Power Back Door Does Not Close Properly

Service Category Vehicle Exterior

Section Door/Hatch

Figure 1.

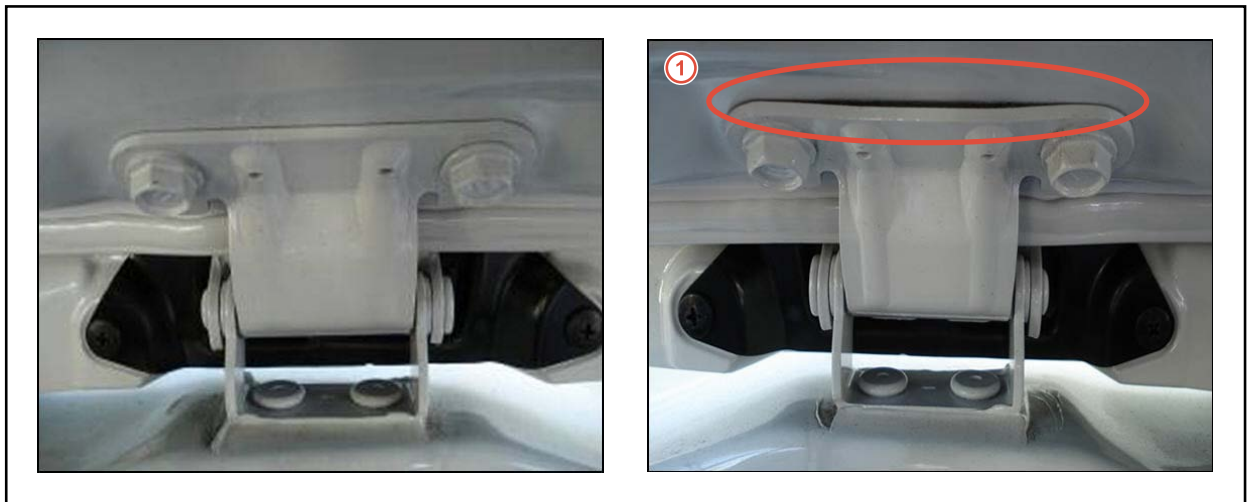
1. Inspect the upper hinges for any gaps present by placing a 0.05 mm (0.002 in.) or greater feeler gauge between the 2 bolts mounted to the back door as shown in Figure 1. If a gap exists, replacement of both Back Door Hinges AND the Back Door Panel Sub-assembly is required. Proceed to step 2.

Figure 2.

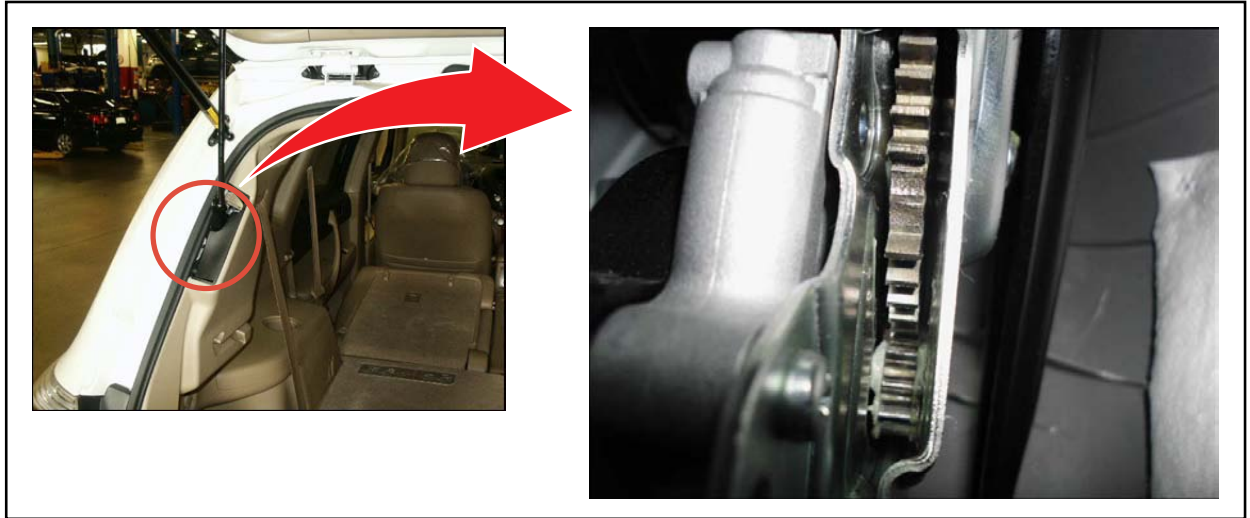
2. Visually inspect the back door motor teeth for damage by opening the back door and manually moving the door towards the half-closed position while observing the large gear teeth for damage, as shown in Figure 2. If damage is found, replacement of the Back Door Motor Unit is required.

Figure 3.

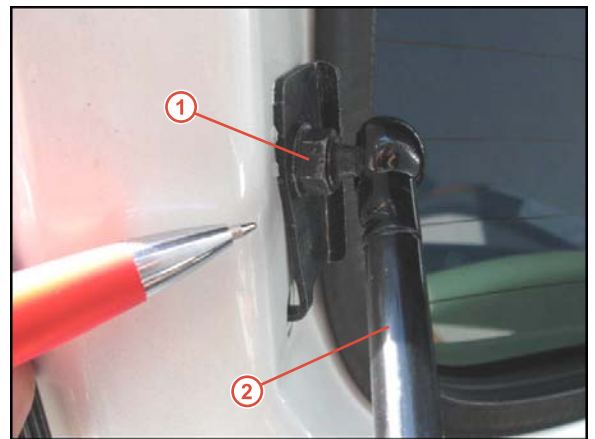
3. Visually inspect the Back Door Upper Rod and Lift Arm Stud for bends or damage. If it is bent, or damage is found, replacement is required.

NOTE
 The Back Door Upper Rod and Lift Arm Stud are available as separate service parts from the Back Door Motor Unit if found damaged or bent.
